# SERVICE LETTER

**SUBJECT: GOODRICH AIRCRAFT WHEELS AND BRAKES CORP. SERVICE BULLETIN 2-1674-32-2**

**GOODRICH AIRCRAFT WHEELS AND BRAKES CORPORATION SERVICE BULLETIN 2-1674-32-2,  
MAIN BRAKE ASSEMBLY P/N 2-1674-1 - INTRODUCTION OF A NEW HIGHER STRENGTH INCONEL  
BOLT AND A COATED NUT.**

**SUBJECT:** Landing Gear - Main Brake Assembly - P/N 2-1674-1 - Model PC-12 Aircraft -  
Introduction of A New Higher-strength Inconel Bolt and A Coated Nut

Figure 1. Lockwire Pattern for Bolts

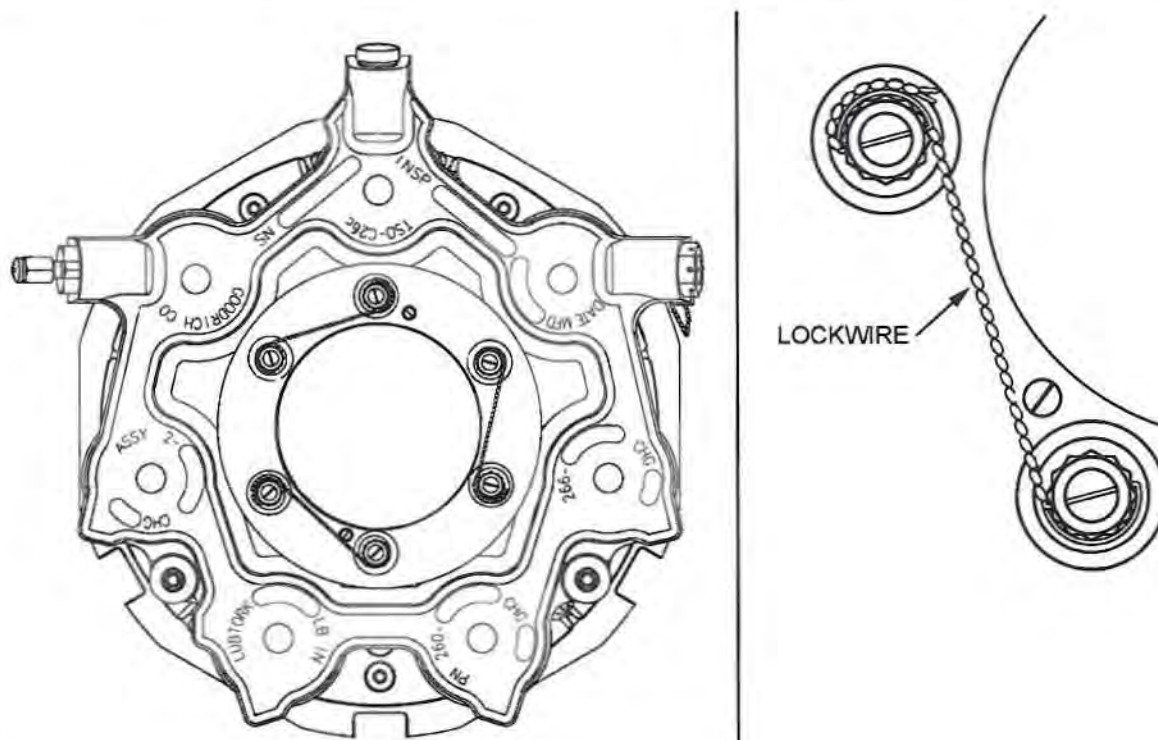
I. Lockwire the bolt heads together with lockwire, P/N MS20995C32 (refer to Figure 1).
